CITY OF OCEANSIDE

Subject: Application Review Committee (ARC), T21-00002, D21-00005, and ~~DB21-00003~~, Vista Way Senior Housing (Assessor Parcel Number: 165-493-47)

Application Review Committee Division Comments- Planning

Project/property address and/or APN: 3710 Vista Way (APN: 165-493-47)

Number: **1024** **FOUND**
 Name: **VISTA WAY & BUENA HILLS**

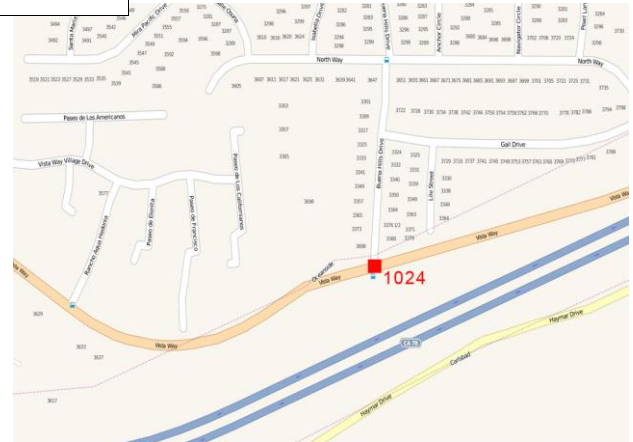
1. Incorrect point number for the benchmark. Attached is the data recovery sheet with the correct point number.
2. No preliminary title report was provided. Provide a copy with next submittal.
